Project: 1694 - Asylum
 121 Center Street
 Portland, Maine 04103

Submittal #237416.13-001.0
237416.13 - PACKAGED LARGE-CAPACITY ROOFTOP AIR-CONDITIONING UNITS

P/D: Large Capacity RTU (Para 1.4A,2)

RTU-7 Drawing

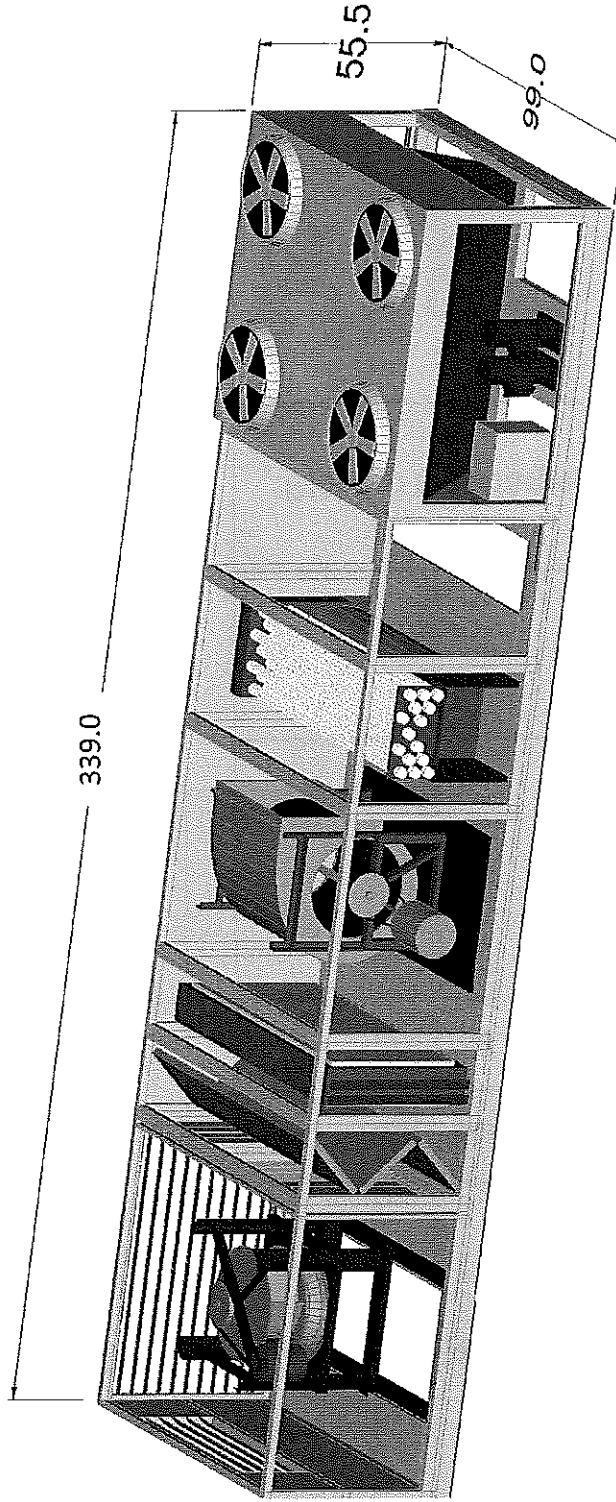
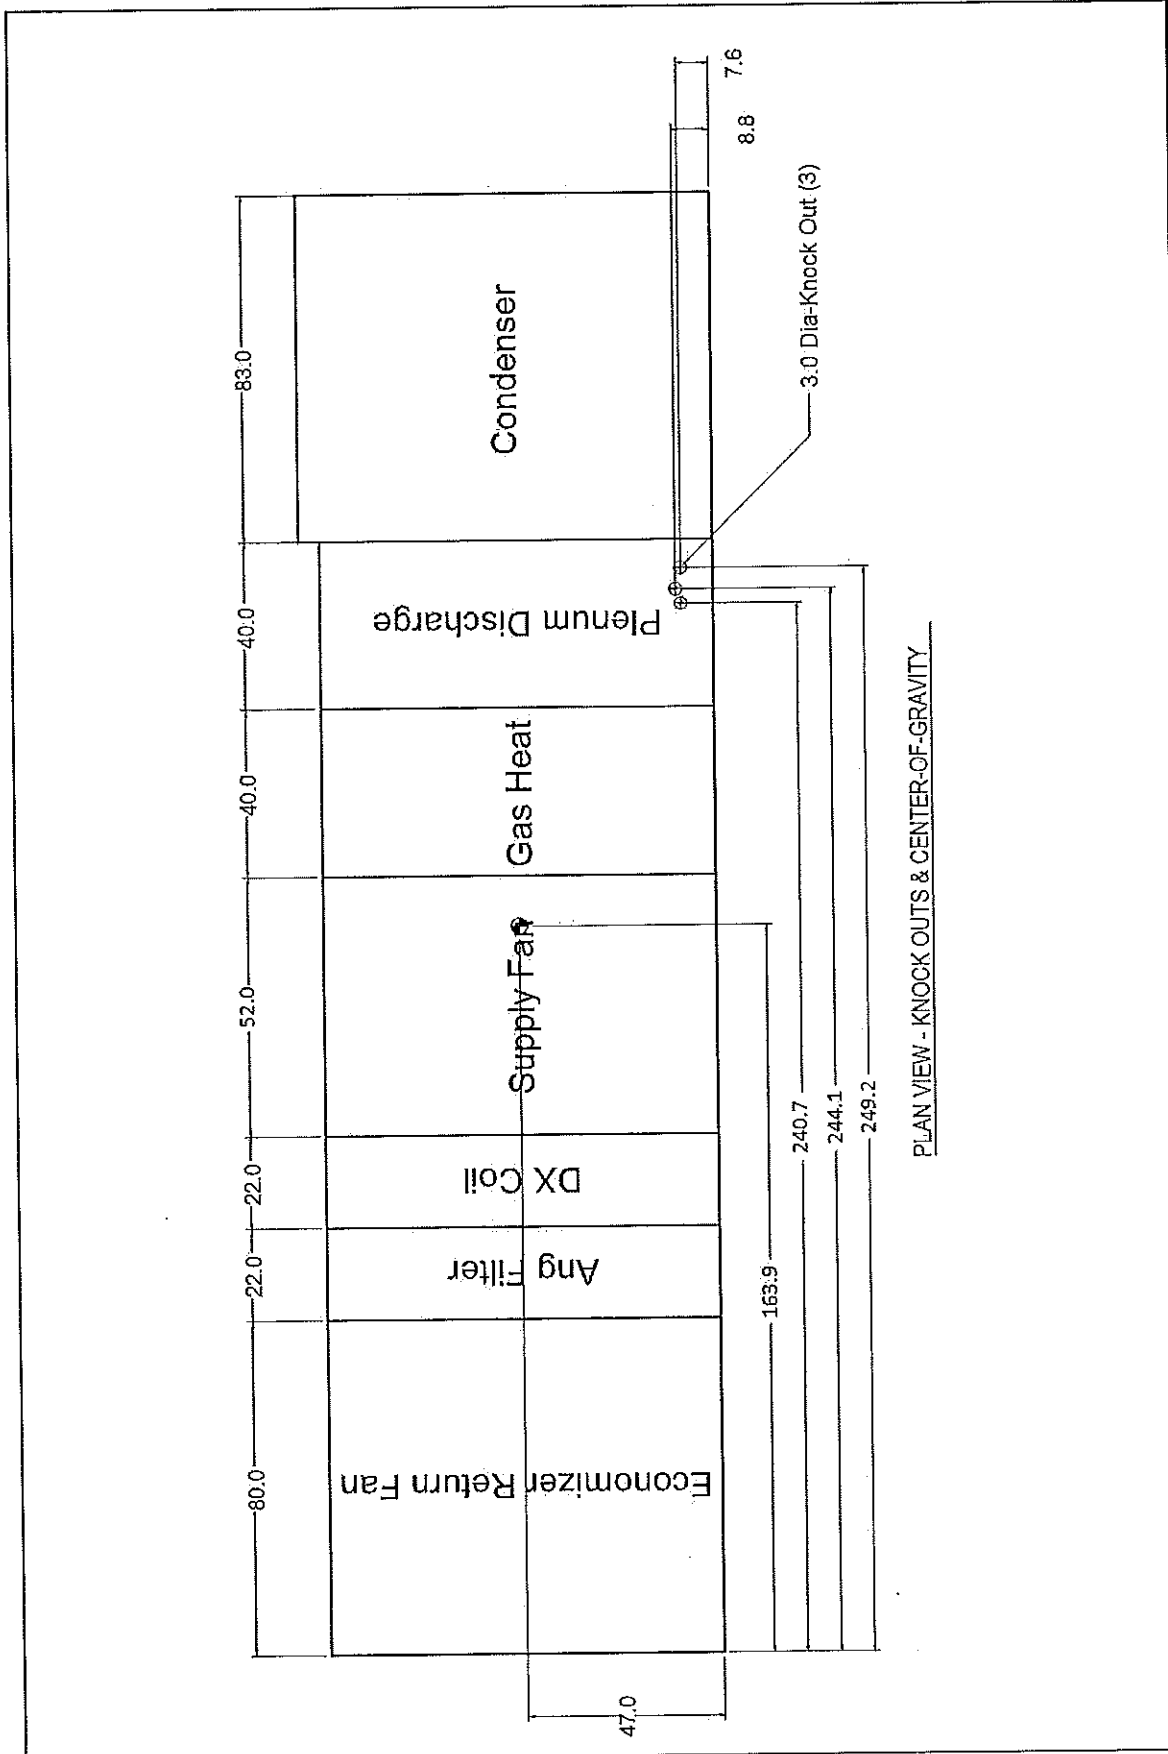
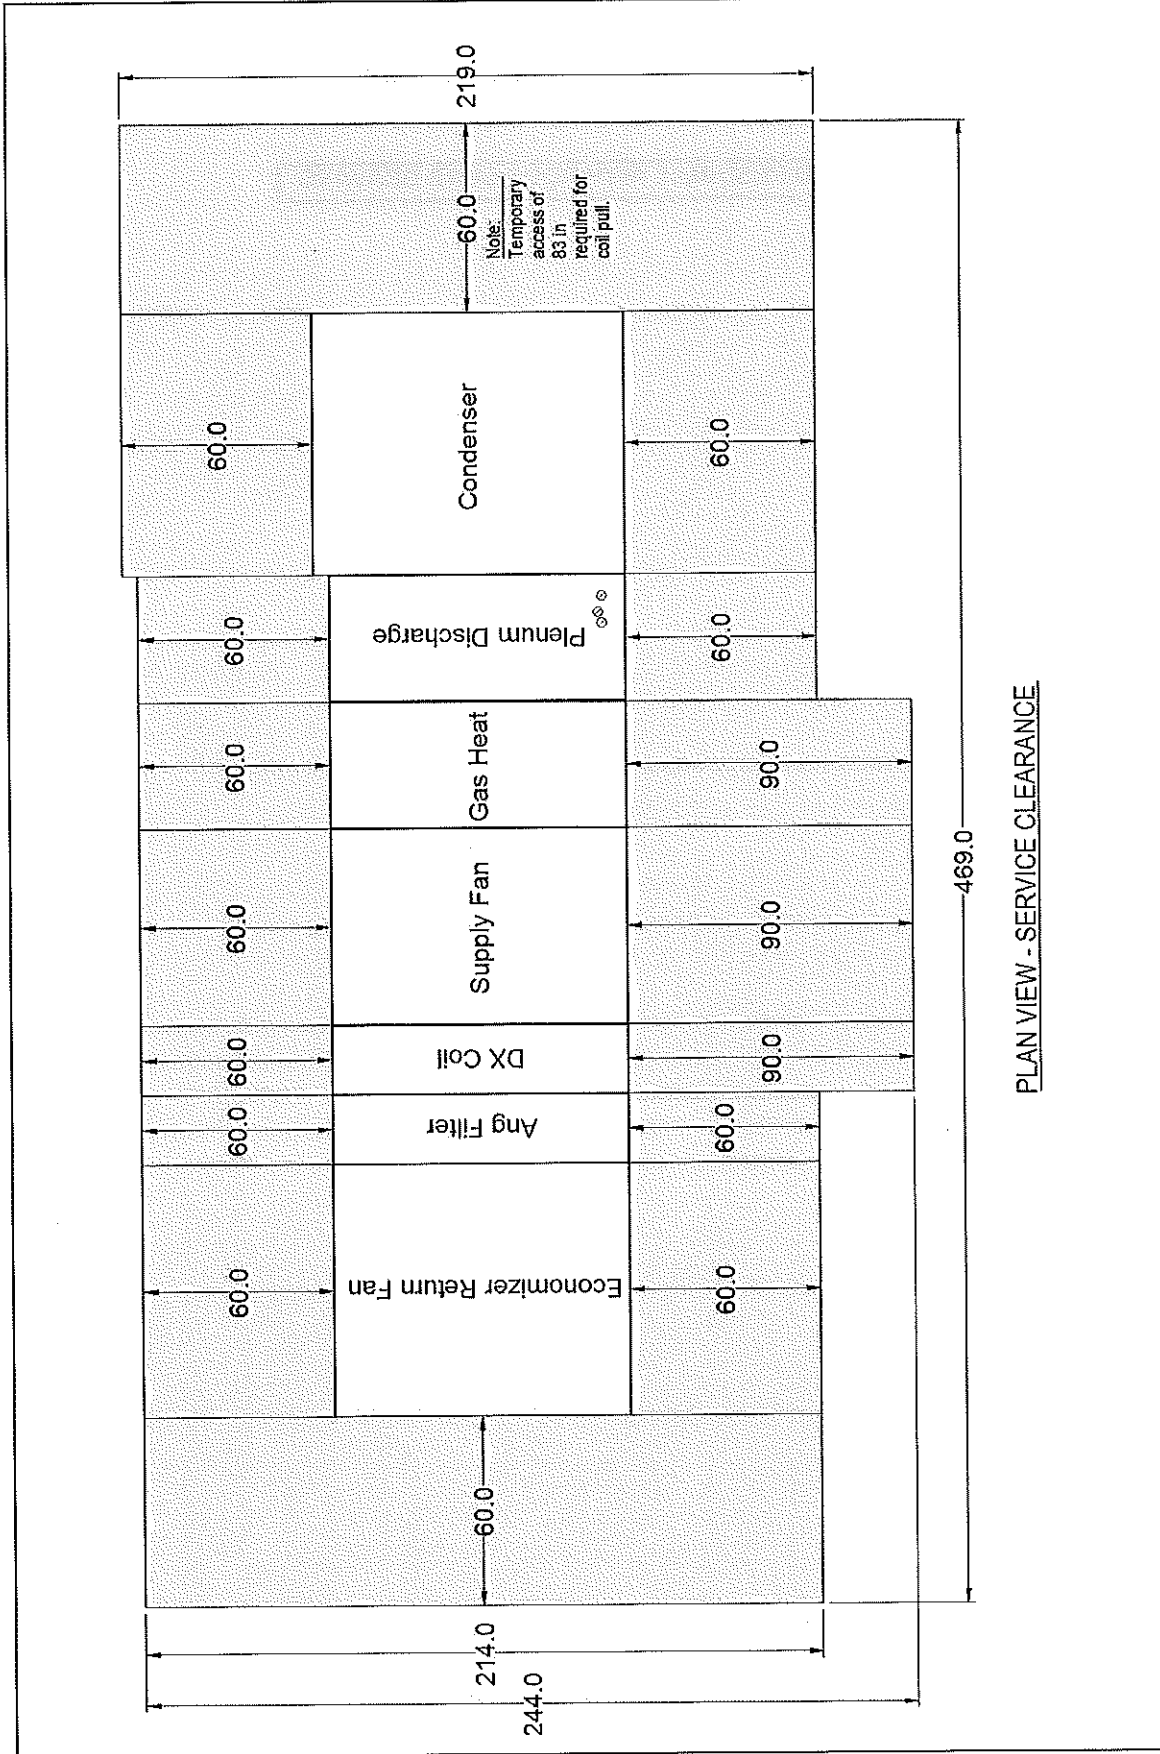
→ Revise and Resubmit RPS035 package including roof curb drawing and controls product data.

Roof Curb Drawing Not Available at This Time.

→ **REVISE AND RESUBMIT WITH ROOF CURB DRAWING**
